ARIZONA DEPARTMENT  
OF  
ENVIRONMENTAL QUALITY

Re: Emission Guidelines for Existing Stationary Sources: Electric Utility Generating Units;  
Proposed Rule; 79 Fed. Reg. 34830 (June 18, 2014)

# Arizona Department of Environmental Quality Comments on Building Block 2

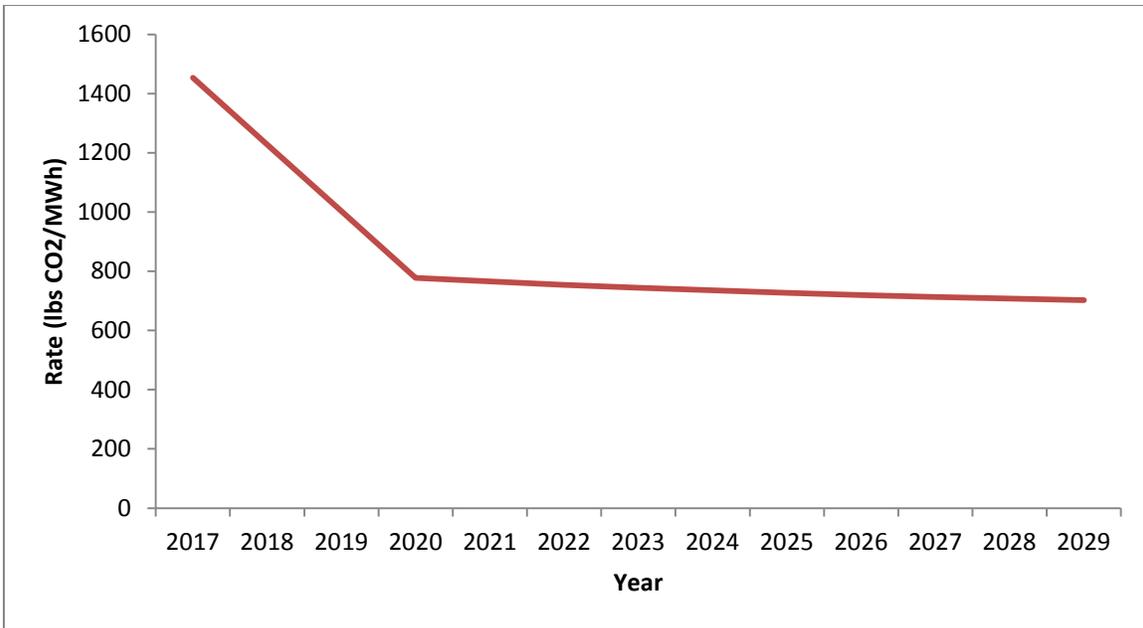
In fact, however, incorporation of the assumed 2020 implementation date for BB2 into the interim goal calculation will have the opposite effect and will interfere with a state's ability to shift from BB2 to measures, such as BB3 and BB4, "whose effectiveness tends to grow over time." Because the interim goal reflects an average of annual values from 2020 to 2029, states cannot shift reductions in generation on a MWh-for-MWh basis from BB2 to BB3 or BB4 without violating the interim goal.

Since application of BB2 to Arizona results in the assumed retirement of the state's entire coal fleet by 2020 and accounts for 81 % of the reduction in the state's adjusted baseline rate,<sup>9</sup> the effect on this state is particularly acute, as shown in the following graph of Arizona's rate reduction curve:

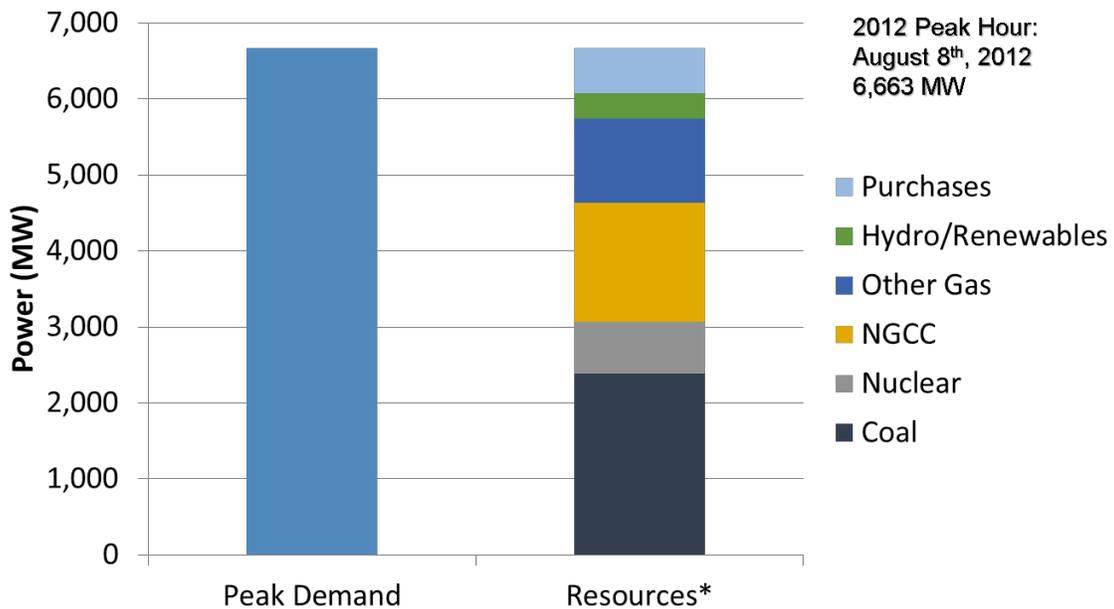
The analysis submitted by APS includes a graph showing what the shortfall in the absence of coal generation would have been throughout the state for the entire month of August 2012, taking all NGCC operating in the state into account:

Actual hourly generation values for the Arizona NGCCs are indicated by the green line. Additional generation that would be required by NGCCs due to the re-dispatch of coal and natural gas steam-fired generation during the same period was added to the NGCC generation to replicate the re-dispatch as proposed by the EPA. These values are indicated by the red line. The figure also shows the maximum possible generation of NGCCs during the summer months (the black line marked 100% CF). The dashed red line shows periods when demand for NGCC generation in the absence of coal would have exceeded capacity. As the graph indicates, NGCC capacity would have been less than needed to meet demand for nearly half the month.

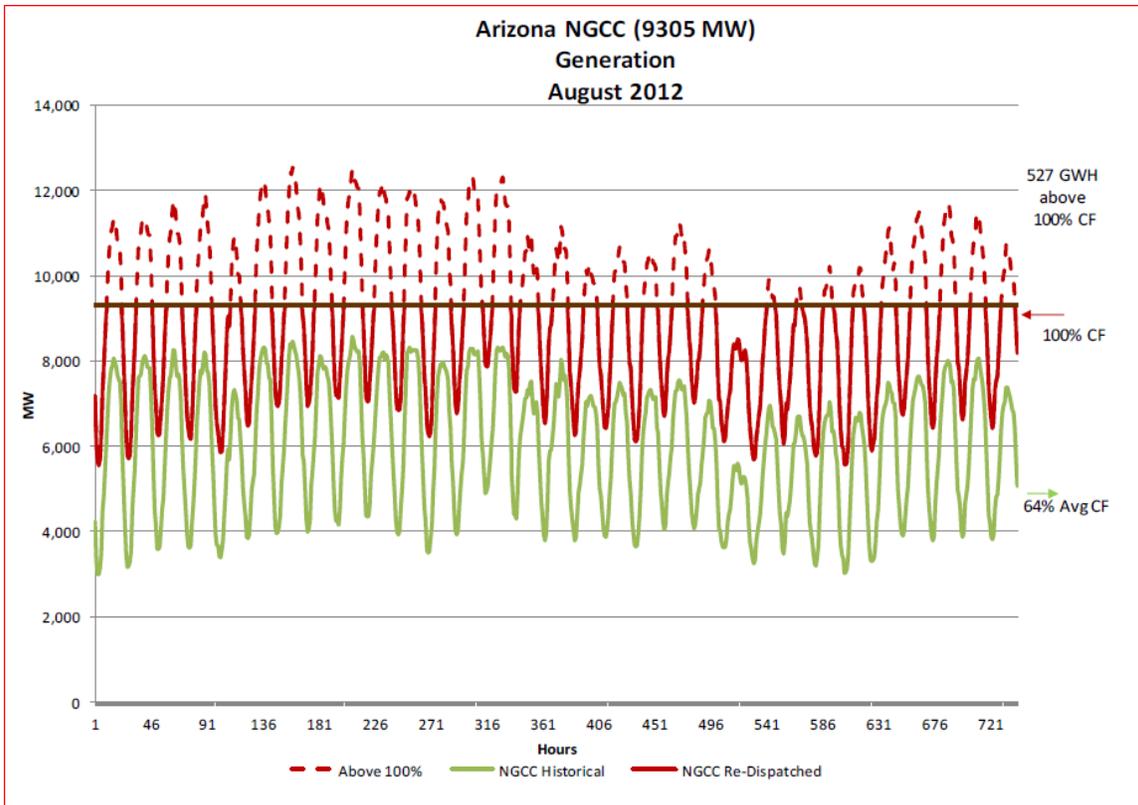
For example, the following figure from the analysis by Salt River Project (SRP) shows a breakdown of the generating resources that were operating during the highest peak hour that SRP experienced in 2012:

During this hour, all available generation resources, including coal and OG steam plants, were being utilized at full capacity to meet that peak demand. Even with all SRP system resources being utilized at full capacity, SRP was still forced to purchase electricity on the open market to meet peak demand and Federally-required reserve requirements. As the graph indicates, if coal generation had not been available, the shortfall would have been over 2,000 MW greater.
